Appl. No.: 10/709,677
Amdt. Dated: 7/3/2006
Reply to Office action of: 04/06/2006

AMENDMENTS TO THE DRAWINGS:

REMARKS/ARGUMENTS

Appl. No. 10/709,677
 Amd. Dated July 3, 2006
 Reply to Office action of 04/06/2006
 Annotated Sheet Showing Changes

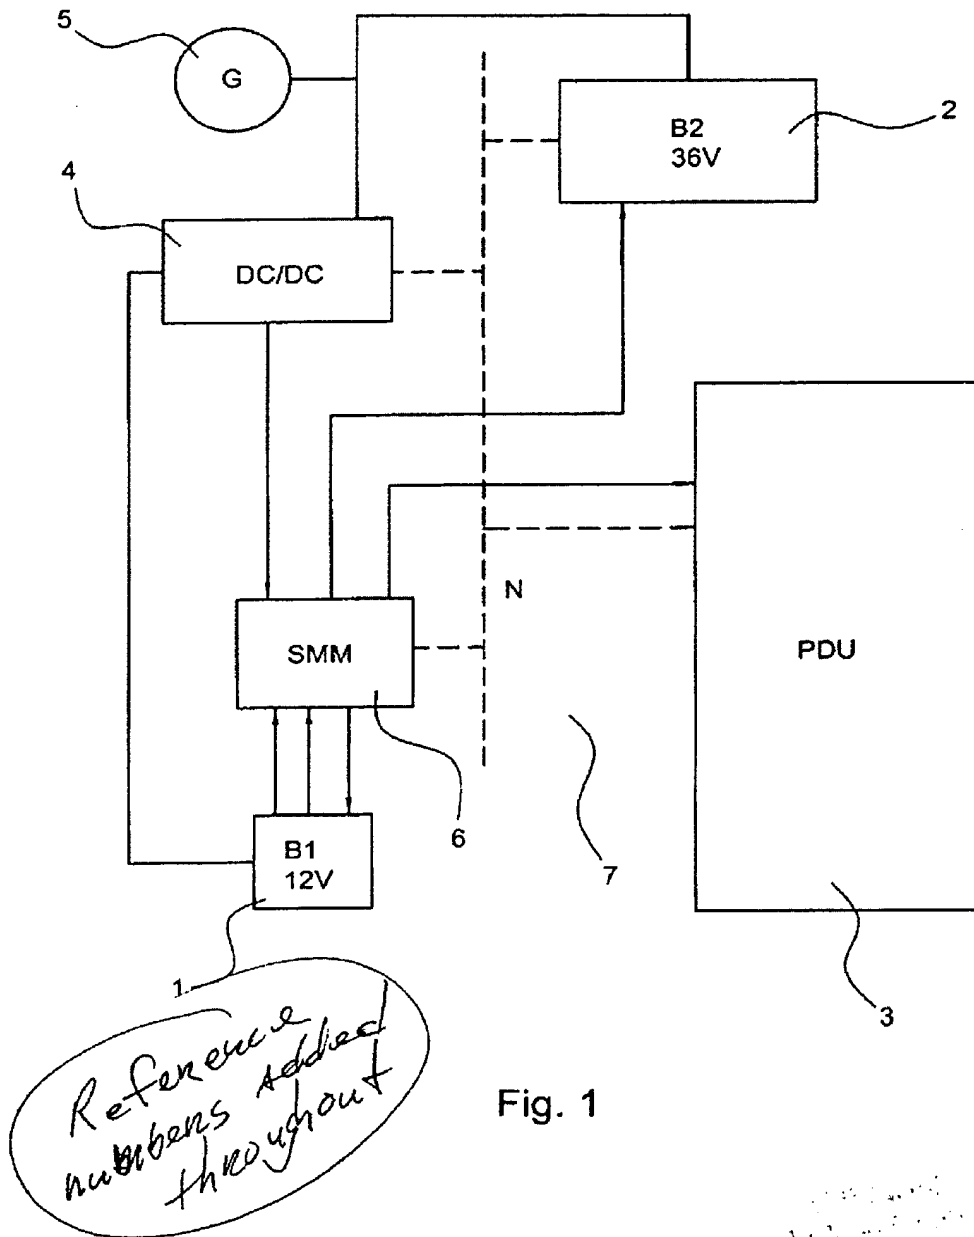
The attached sheet(s) of drawings includes changes to Figures 1 and 2. Figures 1 and 2 have been revised to incorporate numbers for all of the components shown in the drawings and to correct typographical errors in the text labels for these same components per the Examiners requirement.

In amended Figures 1 and 2, have had the labels corrected and reference numbers added as suggested by the Examiner.

The drawings were objected to by the Examiner because of improper labeling and lack of reference numbers. These objections are now overcome by the corrected new drawing sheets comprising Figures 1 and 2. In light of these new drawings Applicants respectfully request these objections to be removed.
